**PROJECT:** Reliability, Safety, and Energy Upgrades to Building Systems for Site Critical Building 4708.

The purpose of this amendment is to answer questions and make clarifications to the Plans and Specifications.

Amendment 1, Reliability, Safety, and Energy Upgrades to Building Systems for Site Critical Building 4708

**RELIABILITY, SAFETY AND ENERGY UPGRADES TO BUILDING SYSTEMS FOR CRITICAL BUILDING 4708 ELECTRICAL GENERAL NOTES AND LEGEND**

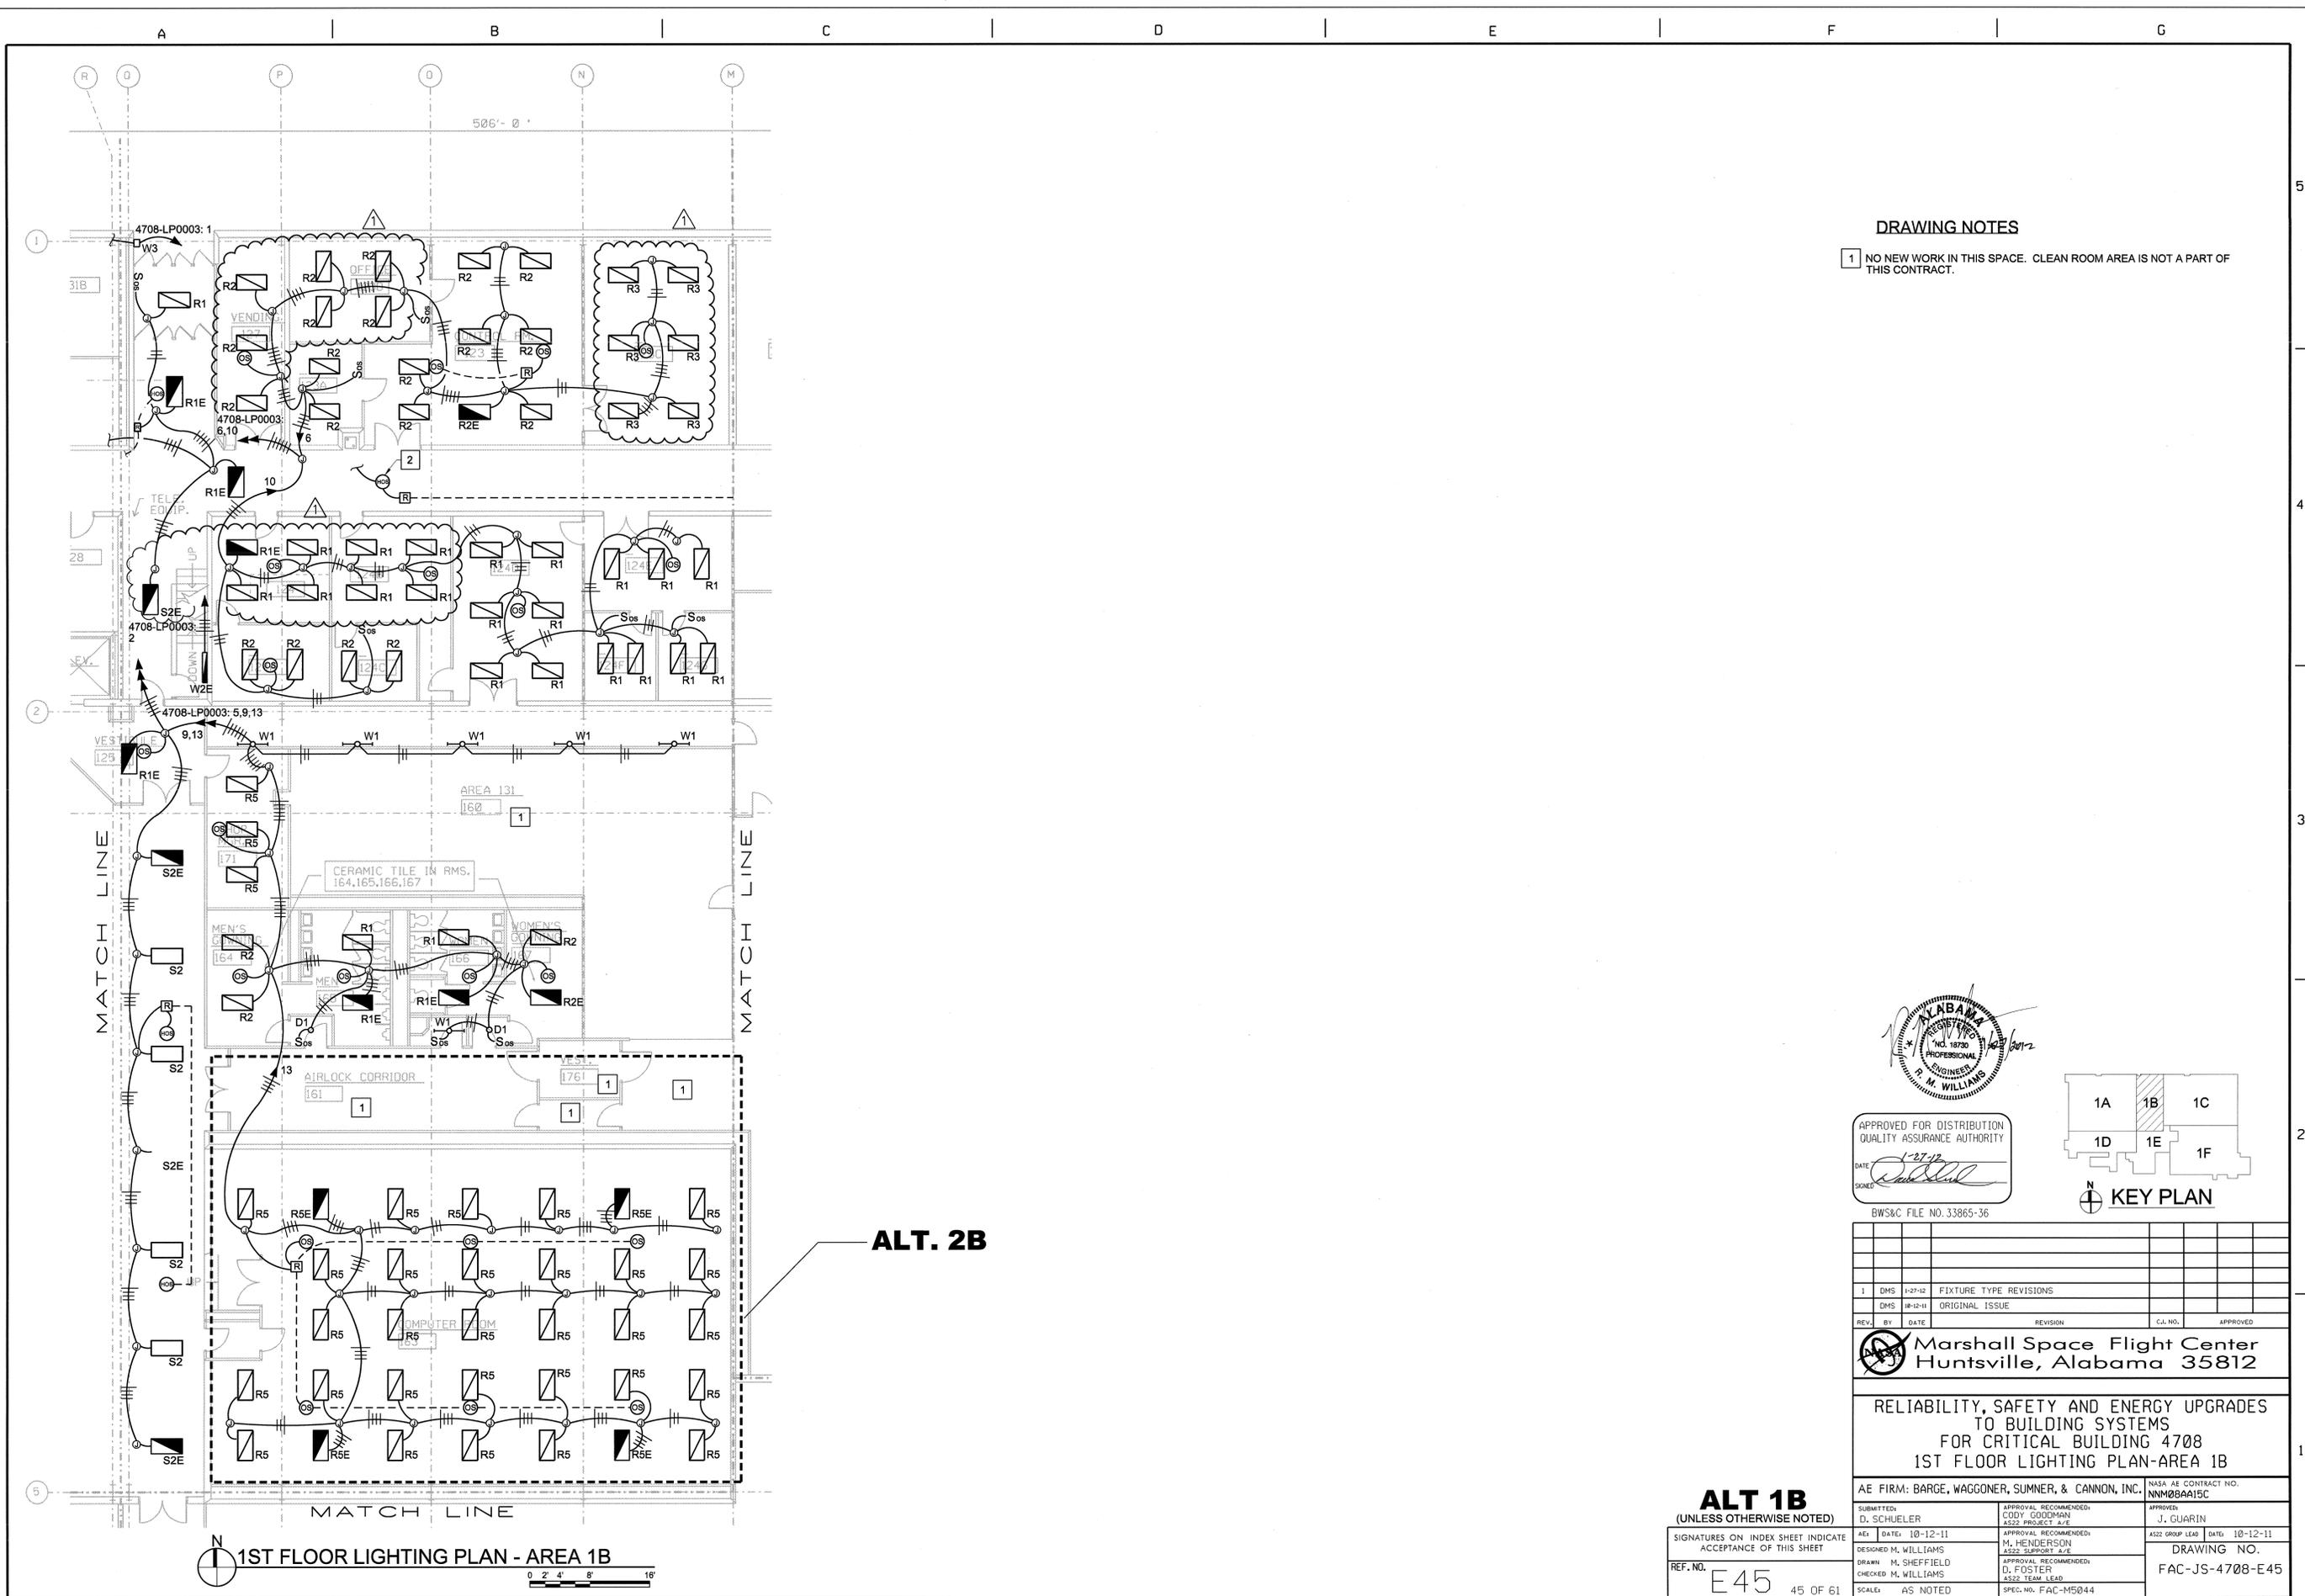
23. Reference: Drawings and Light Fixture Schedule  
Drawing E44 uses Fixture Tag S1, S1E, and S5  
Drawing E45 uses Fixture Tag S1, S1E, and R5E  
Drawing E46 uses Fixture Tag S1, S1E, and S5  
Drawing E49 uses Fixture Tag S1, S1E, and Y1  
Drawing E52 uses Fixture Tag S1 and S3E  
Drawing E54 uses Fixture Tag R4  
Drawing E55 uses Fixture Tag S1, S1E, and R4  
These Fixture Tags are not on the Light Fixtures Schedule.

Could you provide the right Fixture Tag or provide the fixture information as it would be shown on the Light Fixture Schedule?

**Response:** Bid per revised contract drawings FAC-JS-4708-E1, -E44, -E45, -E46, -E49, -E52, and -E55 included herein.

# CURRENT OPERATED SWITCH

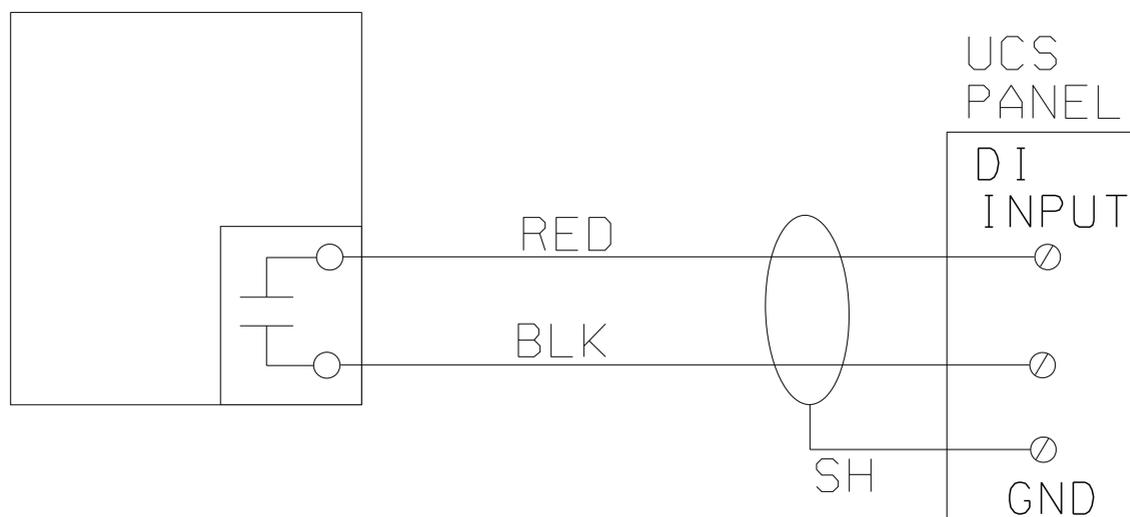
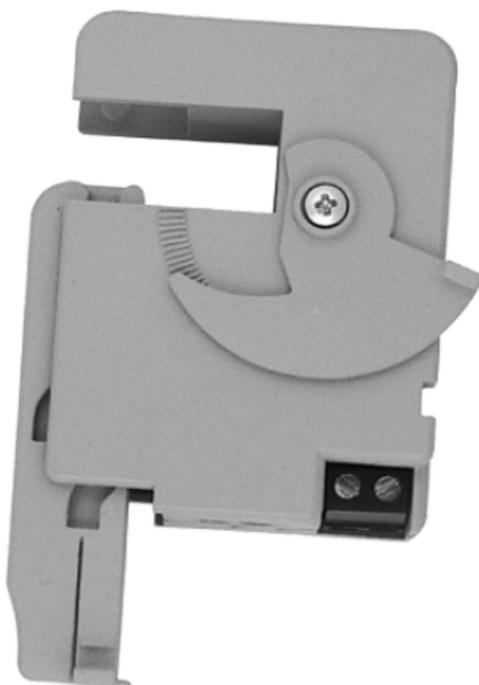
24. Connect 4708B-AH1-SAF VFD serial connection to Card 4, serial port" SP4". Label SP4 as "B-AH1-SA\_VFD"
25. On sheet UCS13, replace the field device "SK DP2/SPP1" with "SK ISW2" for "DI" point 4708C-AH1-SAF on existing panel 4708B-UCS0001, card 1, channel UI2.
26. Change all field devices listed as "SK ISW1" to "SK ISW2" on all applicable UCS wiring details. See SK ISW2 (attached).
